LOT 311 GNULLI COURT, EXMOUTH

LOT 311, GNUILLI COURT, EXMOUTH : APPLICATION FOR PLANNING APPROVAL.

The following are further responses to specific planning comments received from the Shire on 5 May 2016 (Please refer to Appendix B for the Shire's preliminary planning comments).

**LOT 311 GNULLI COURT, EXMOUTH
PROPOSED SINGLE HOUSE
RESPONSE TO PRELIMINARY ASSESSMENT**

02 ROOF PLAN
SCALE 1:100

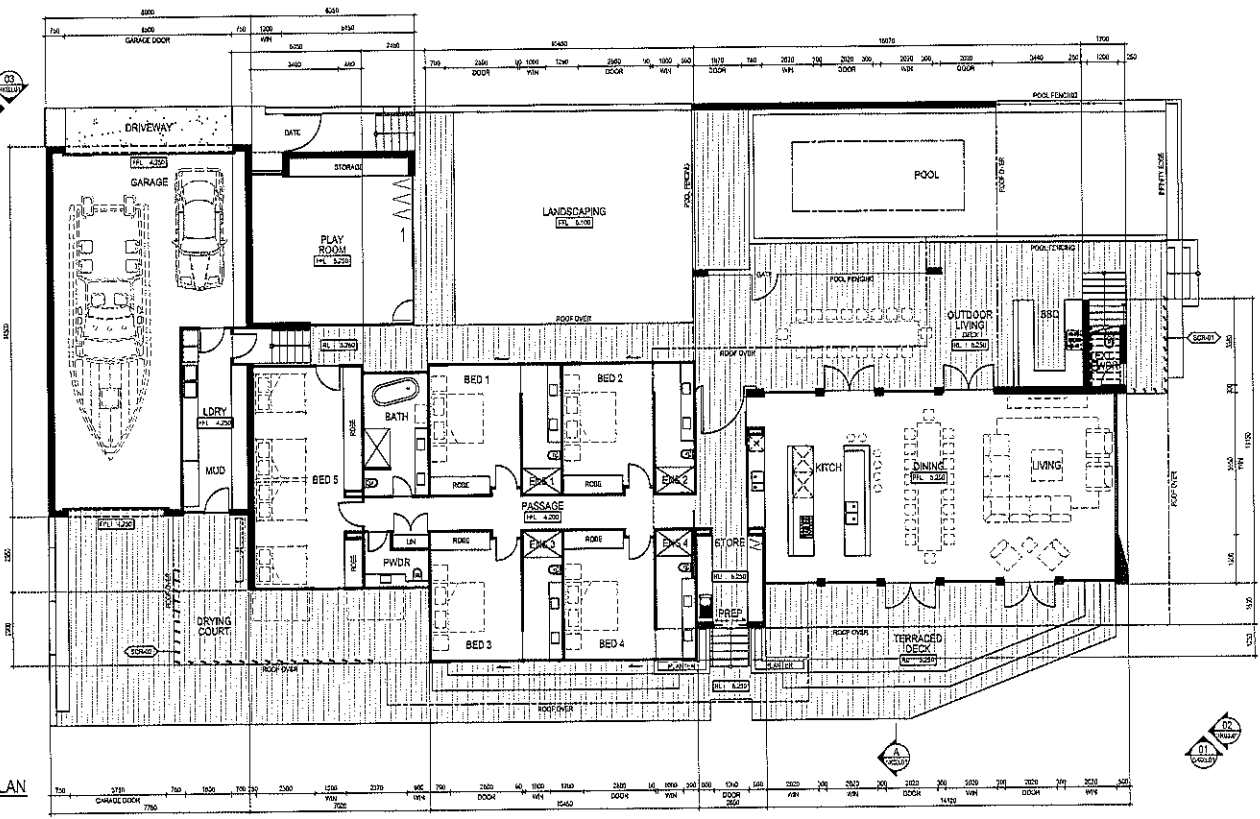
- a) The Shire's comment makes reference to a roof terrace along the north eastern boundary of Lot 311. The roof along this boundary, does not function as a roof terrace and will not be accessible as an outdoor living area. The proposed roof terrace is located above the living area, only.
- b) The pool walls have been been setback to be located within the NDA to perserve canal views for neighbouring property Lot 312, as stated in item 3).

01 SITE PLAN
1:200

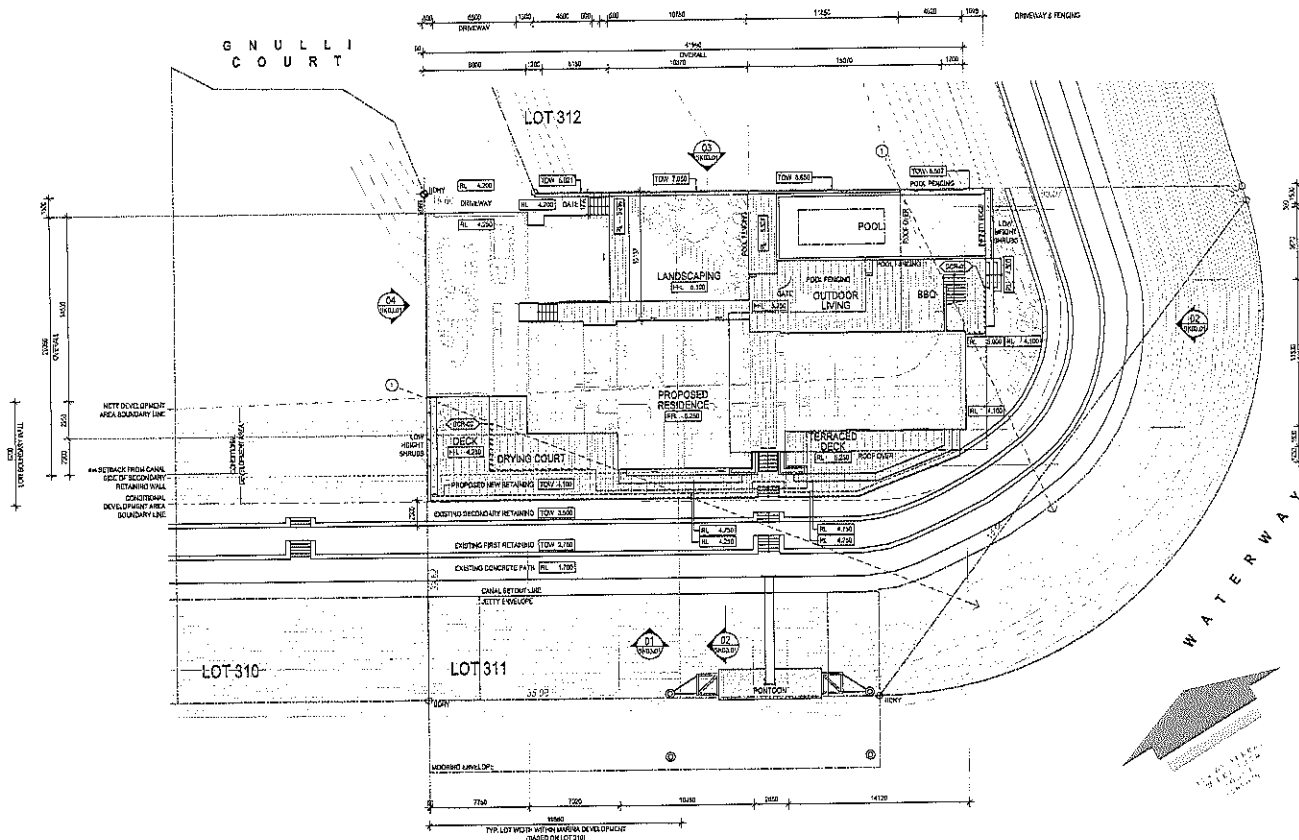
- 1) Setback of garage to within the NDA.
 - a. Please refer to plotted sight line on drawing SK01.01, extrapolated from the intersection of the NDA boundary line with the cadastral boundary line shared by neighbouring Lot 310 and Lot 311, to the furthest projection of the proposed residence.

- b. This plotted sight line demonstrates that the garage setback preserves the canal views from neighbouring Lot 310.
 - c. Further to this, no structures, open or otherwise have been proposed to the CDA area in between the canal and the garage on Lot 311. An indicative boundary line, shown on Lot 311, projects the extent of a typical lot width of 19.56m. This gives perspective to the reasonable level of preservation of canal views from neighbouring Lot 310.

- 2) Setback of proposed walls adjacent to pool, to within the NDA.
 - a. Please refer to plotted sight line on drawing SK01.01, extrapolated from the intersection of the NDA boundary line with the cadastral boundary line shared by neighbouring Lot 312 and lot 310, to the furthest projection of the proposed residence.

- b. This plotted sight line demonstrates that the setback of the pool walls to within the NDA preserves canal views from neighbouring Lot 312.
 - c. The proposed external stair to the roof terrace is the furthest projection of the proposed residence which could serve as visual impediment. The stair is currently shown with visually permeable glazed balustrading to allow the neighbour’s vista to extend further.
